# Access Compliance Report

## Public Rights-of-Way (Curb Ramps)

Intersection ID: 31771	Main Street: STARNES RANDALL RD	Cross Street: PINYON PINE LN	Location: NE
ADA ID: 91A785C7CBB3	Ramp Type: Perp	Initial Pass/Fail: Fail	Overall Compliance: No
Severity Score: 25			
Codes/Mitigation Info/Possible Solution		Field Measurements/Component Compliance

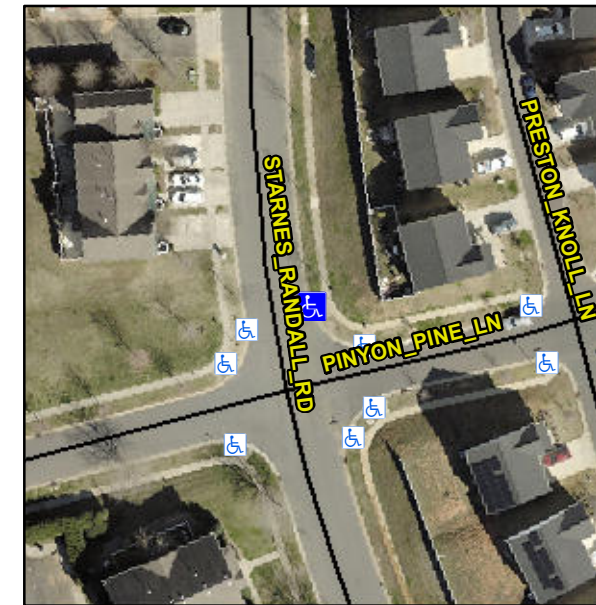
**R304.2.2, R304.5.3**

Compliance	Description	Data	Compliance	Description	Data
N/A	Ramp Length (in)	82.0	No	Ramp Slope (%)	9.8
Yes	Ramp Width (in)	53.0	No	Ramp XSlope (%)	5.3
N/A	Flare Type LT	N/A	N/A	Flare Type RT	N/A
N/A	Flare Slope LT (%)	N/A	N/A	Flare Slope RT (%)	N/A
N/A	Flare Traversable LT?	N/A	N/A	Flare Traversable RT?	N/A
N/A	Landing Length (in)	N/A	N/A	DWS Provided?	N/A
N/A	Landing Width (in)	N/A	N/A	DWS Contrast?	N/A
N/A	Landing Slope (%)	N/A	N/A	DWS Length (in)	N/A
N/A	Landing X Slope (%)	N/A	N/A	DWS Full Width?	N/A
N/A	Landing Curb? (Y/N)	N/A	N/A	DWS Offset (in)	N/A
N/A	Shared Landing?	N/A			
N/A	Gutter Ponding?	N/A	N/A	Gutter Slope (%)	N/A
N/A	Gutter Lip Ht (in)	N/A	N/A	Gutter X Slope (%)	N/A
N/A	Painted X Walk1?	No	N/A	Painted X Walk2?	N/A
	X Walk 1 Direction	To W		X Walk 2 Direction	N/A
N/A	X Walk 1 Width (in)	N/A	N/A	X Walk 2 Width (in)	N/A
	X Walk 1 Slope (%)	3.3		X Walk 2 Slope (%)	N/A
	X Walk 1 X Slope (%)	2.0		X Walk 2 X Slope (%)	N/A

**Remove & Replace Entire Ramp.**
